**BOARD OF ZONING ADJUSTMENT
STAFF REPORT****Date: August 1, 2011**

<u>CASE NUMBER</u>	5685
<u>APPLICANT NAME</u>	Advanced Disposal Services Gulf Coast, LLC (Joe Stevens, Agent)
<u>LOCATION</u>	6225 Rangeline Road (East side of Rangeline Road, 1400'± North of Old Rangeline Road).
<u>VARIANCE REQUEST</u>	PARKING SURFACE: Parking Surface Variance to allow a gravel parking and maneuvering area for a disposal and recycling facility in a B-5, Office-Distribution District.
<u>ZONING ORDINANCE REQUIREMENT</u>	PARKING SURFACE: The Zoning Ordinance requires parking and maneuvering areas to be paved with asphalt, concrete, or an approved alternative paving surface in a B-5, Office-Distribution District.
<u>ZONING</u>	B-5, Office-Distribution
<u>AREA OF PROPERTY</u>	1.0± Acre
<u>TRAFFIC ENGINEERING COMMENTS</u>	No comments.
<u>CITY COUNCIL DISTRICT</u>	District 4

SITE PLAN

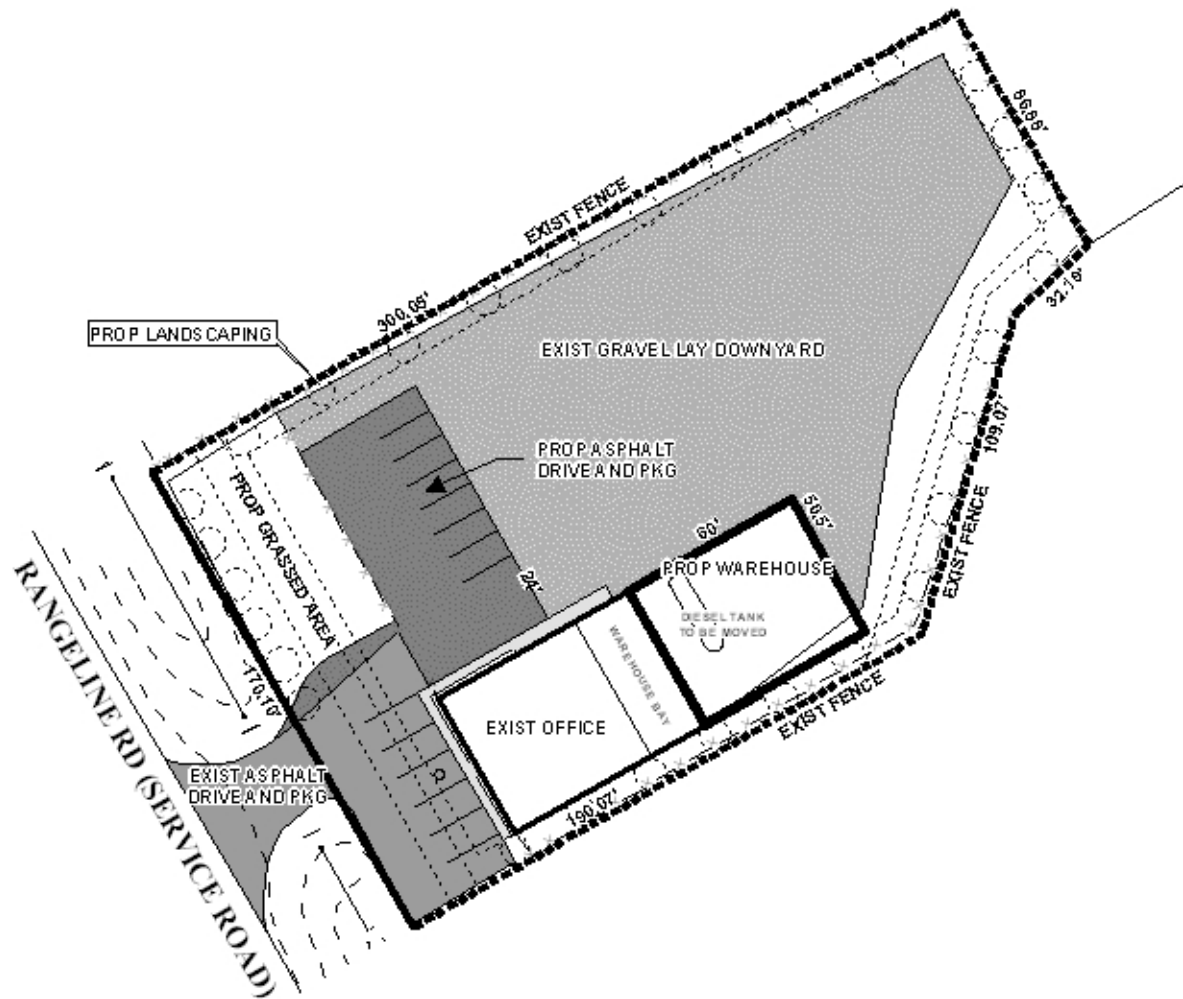
A revised site plan and narrative were submitted. The existing 3,560 square-foot building is proposed to be expanded to approximately 6,590 square feet. The revised site plan indicates expanded and paved vehicular parking for seven standard vehicles and compliance with landscaping and tree planting requirements. However, the six existing parking spaces in front of the building with noncompliant 20' access/maneuvering area remain and the applicant has asked that they be allowed to continue in use. Since the total office space in the building will be

2,555 square feet, eight compliant parking spaces would be required, but no parking requirements were furnished for the service bay areas, so total required parking for the site cannot be determined. It appears that there may be sufficient area on the site to shift the existing parking directly in front of the building to the proposed front grass area and vice versa to gain fully compliant parking and retain required frontage landscaping area. Compliant parking should include parking spaces meeting the requirements of the Americans with Disabilities Act (ADA). The revised narrative explains that the gravel-paved area is used as a laydown yard for the dumpsters that are loaded and unloaded on-site. Typically, the Board has been sympathetic to the granting of Surface Variances where heavy equipment and items are stored and moved due to the potential for damage to compliant paved surfaces.

Based on the preceding, the request to allow a gravel parking and maneuvering area within the laydown yard is recommended for approval, subject to the following conditions:

- 1) revision of the site plan to indicate fully compliant standard vehicle and ADA parking by swapping the existing parking in front of the building with the proposed grassed area on the site plan, and furnishing of substantiating parking ratio calculations and frontage landscaping area calculations; and
- 2) full compliance with all other municipal codes and ordinances.

The request to allow the existing nonconforming parking to remain in front of the building is recommended for denial.
